STATE HIGHWAY COMMISSION OF KANSAS  
 BR. NO. 13-75-19 STA. 154 + 24.50

ENGINEERING GEOLOGY  
 CEDAR CREEK BRIDGE

PROJ. 13-75 K1014 (3) POT TAWATOMIE CO.

SHEET NO. 5 OF 8	SCALE	APP'D
DESIGNED	DETAILED	QUANTITIES
DESIGN CK.	DETAIL CK.	QUAN. CK.
		TRACED
		TRACE CK.

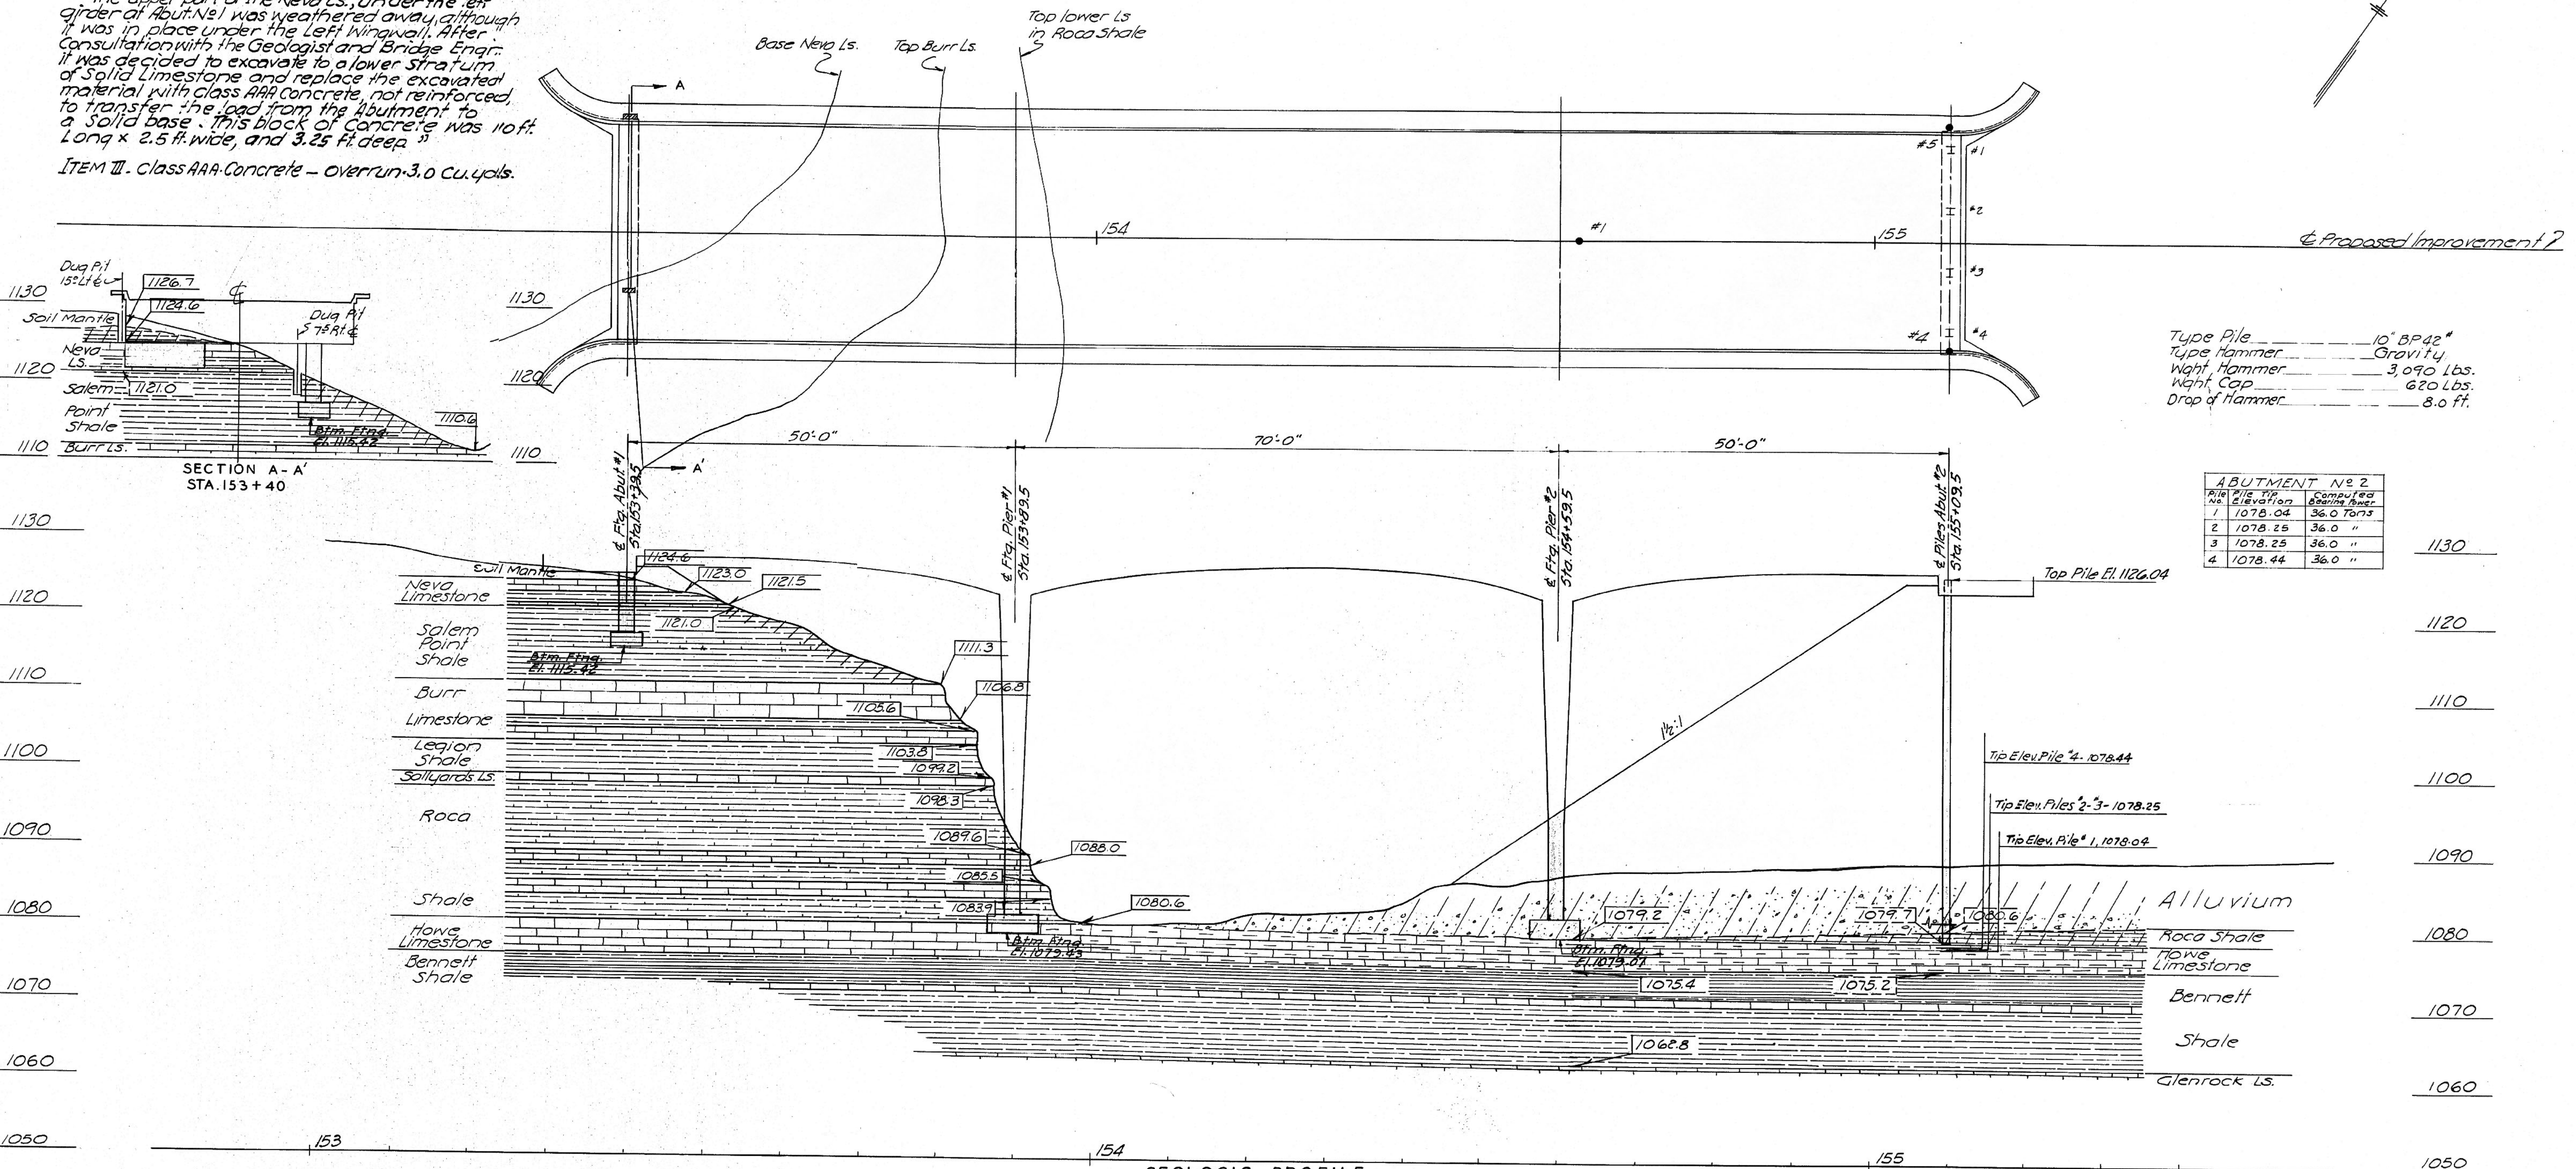
"The upper part of the Neva Ls., under the left girder of Abut. No. 1 was weathered away, although it was in place under the left wingwall. After consultation with the Geologist and Bridge Engr., it was decided to excavate to a lower stratum of Solid Limestone and replace the excavated material with class AAA concrete, not reinforced, to transfer the load from the abutment to a solid base. This block of concrete was 110 ft. Long x 2.5 ft. wide, and 3.25 ft. deep."

ITEM III. Class AAA Concrete - Overrun 3.0 CU. Yds.
